1435 - P045a

Entrance Hall//Existing//Plan_1:20

1435 - P050a

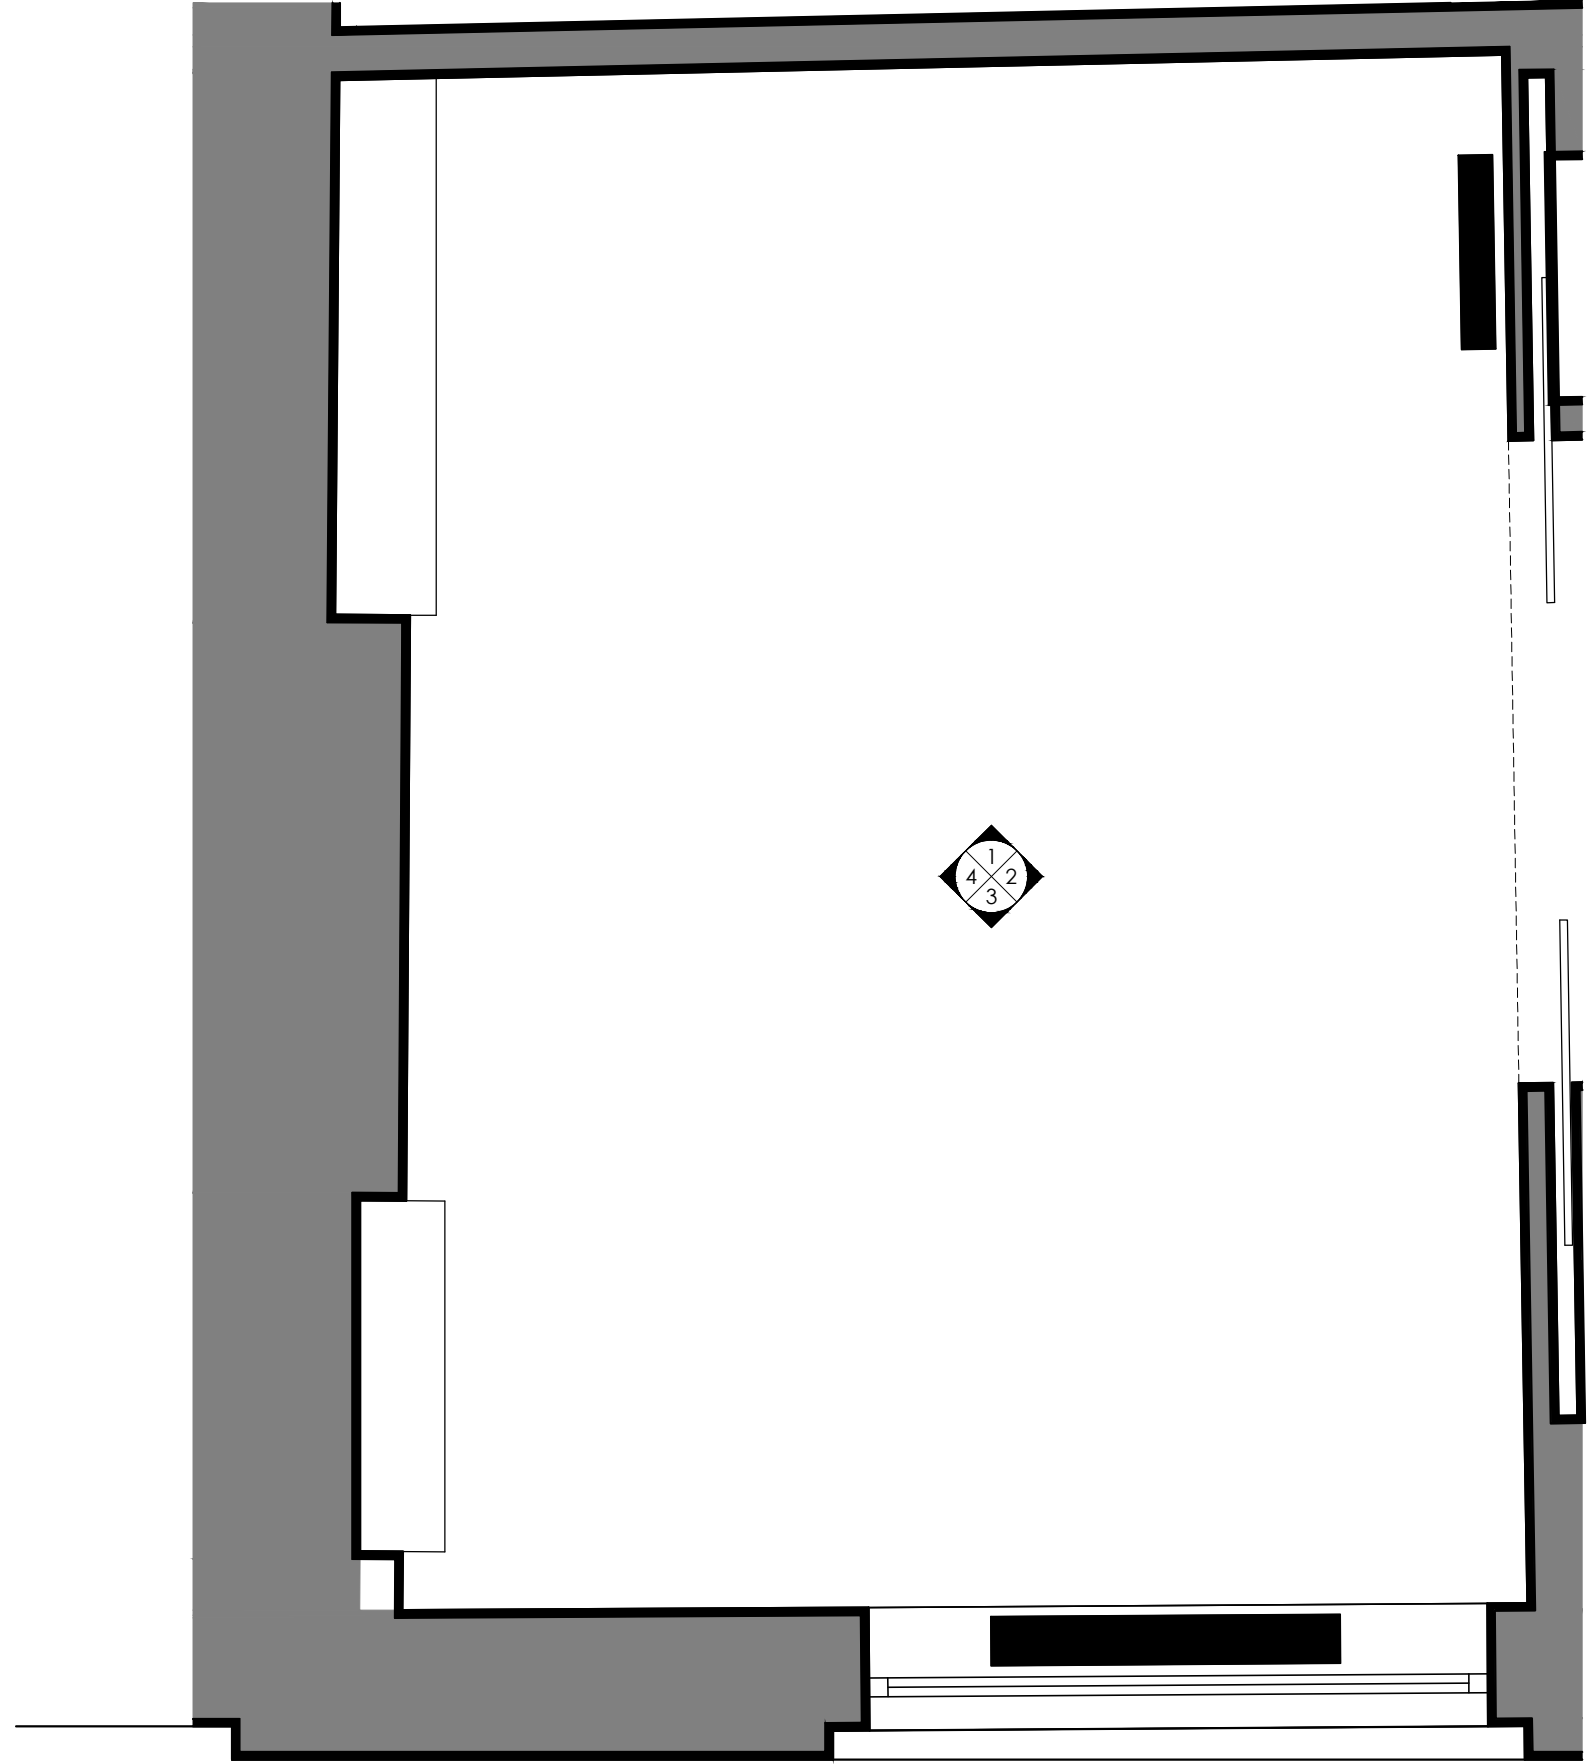
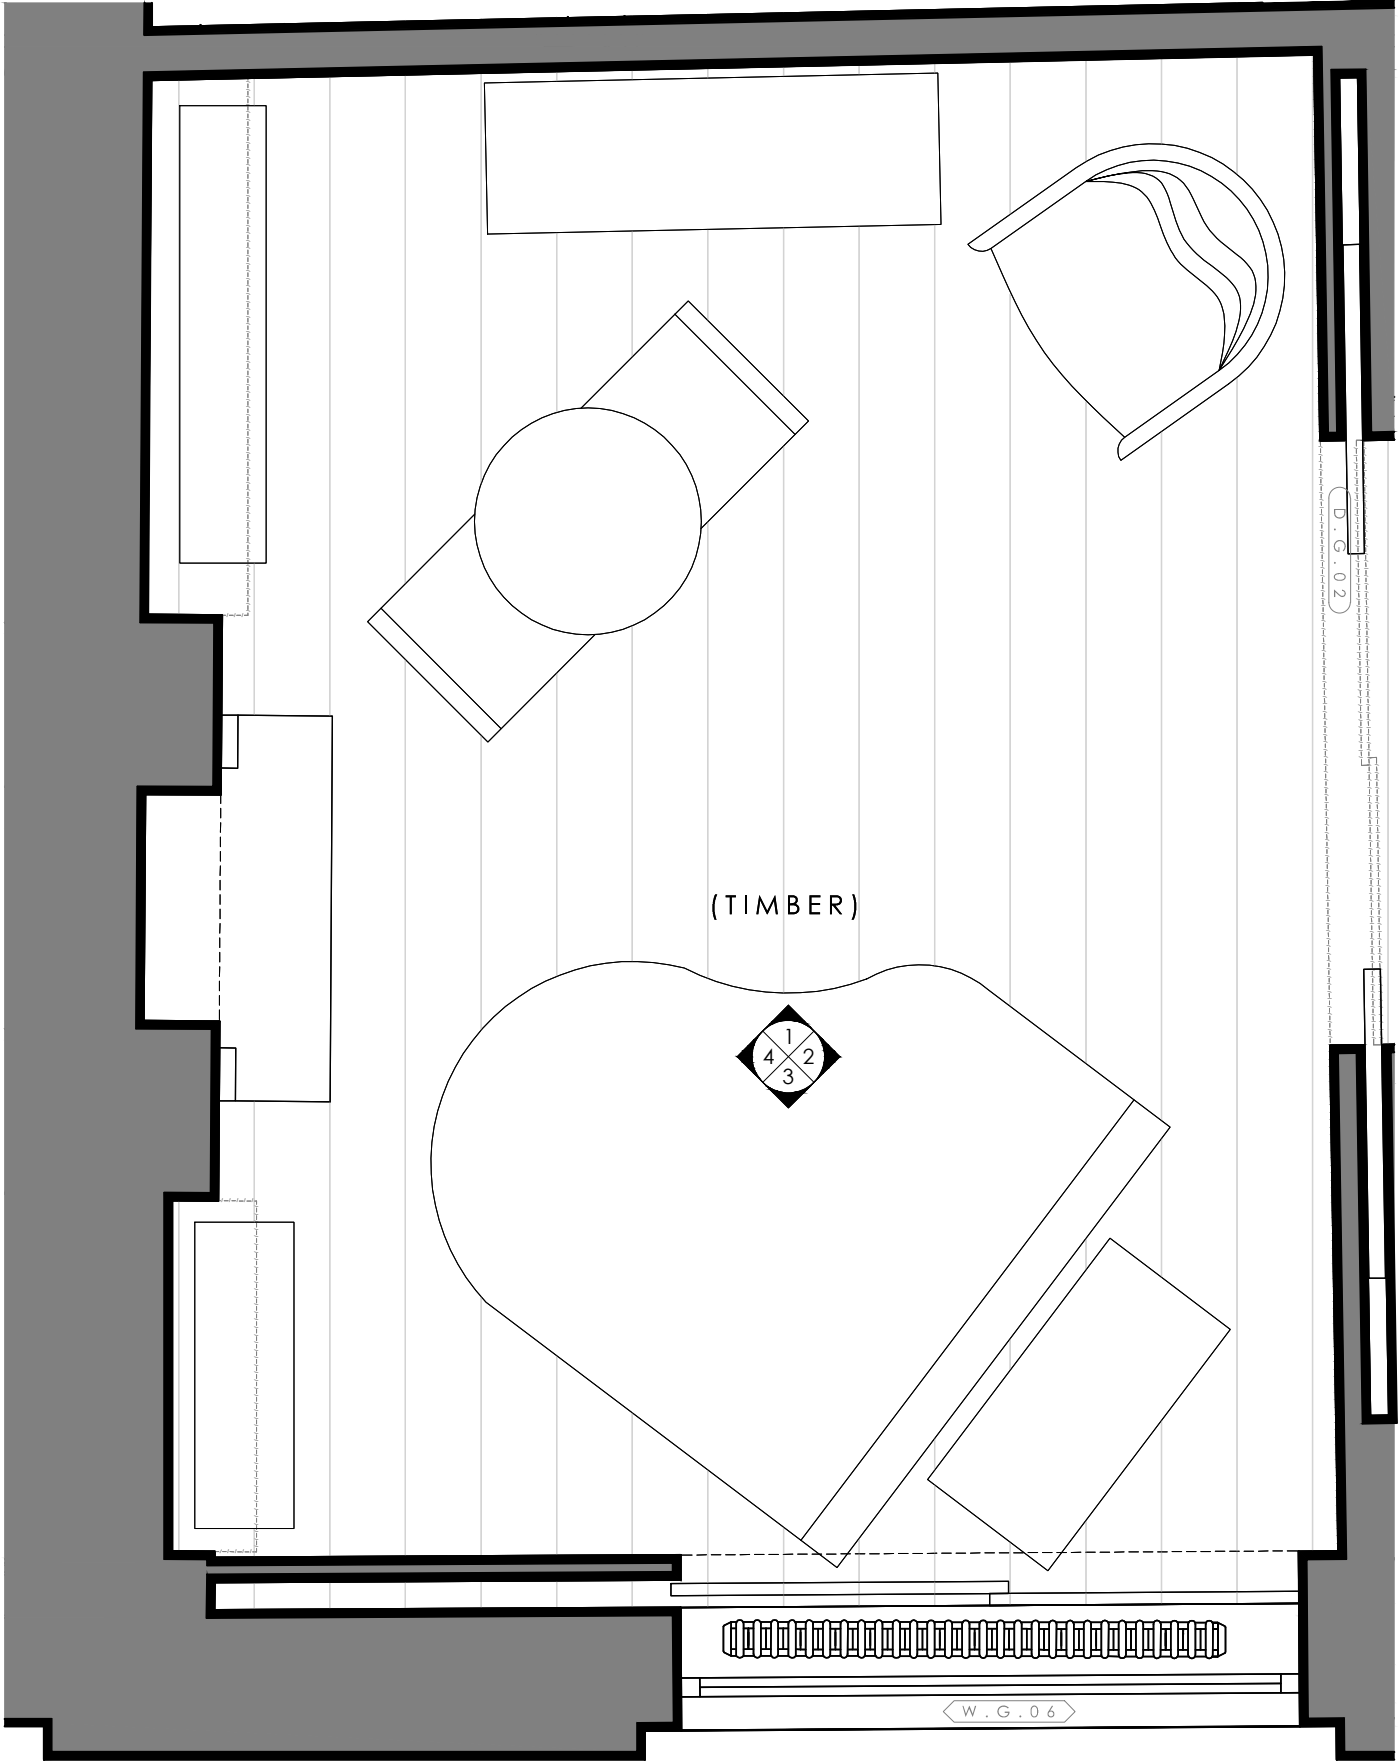
Rev	Date	Notes
A	14.05.15	Drawing revised following comments from council.

Rev	Date	Notes
A	23.06.15	Radiator added.

1435 - P051

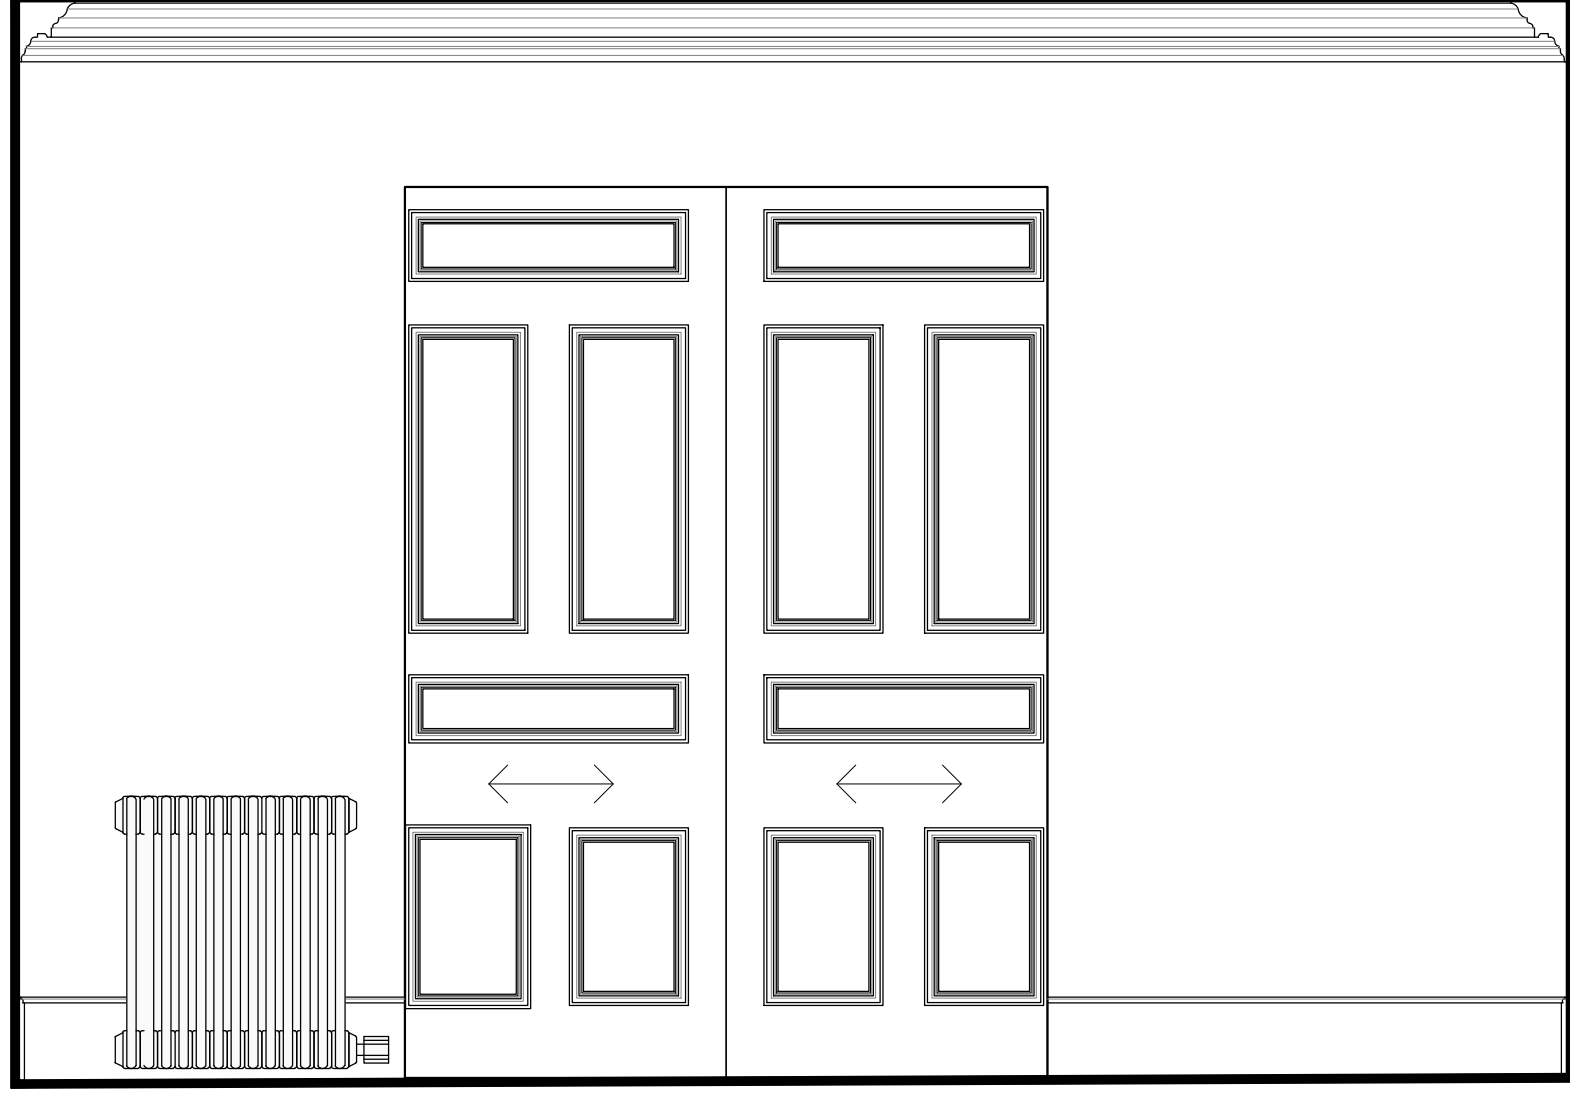
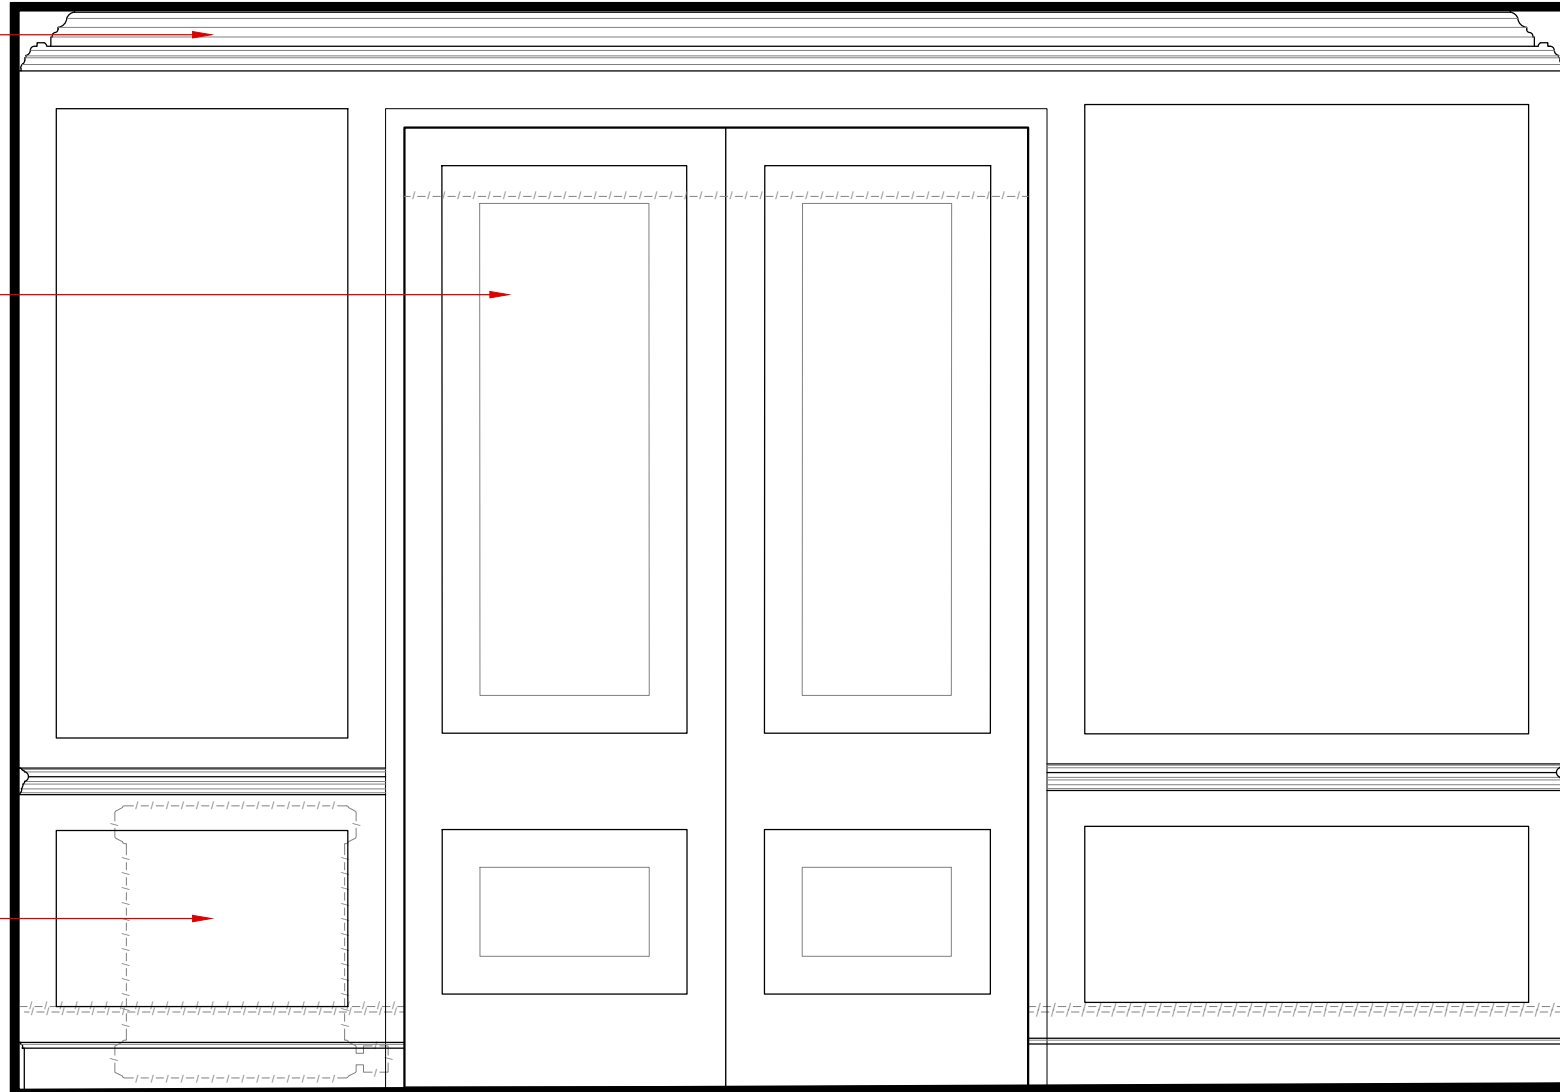
Proposed simple
panelling to match
existing within Drawing
Room.

Proposed cornice to
adjusted wall to match
existing.

Proposed opening to be
centralized and head
height raised to suit
panelling. Doors to
match D.G.06. New
sliding mechanism.

Existing column radiator
removed.
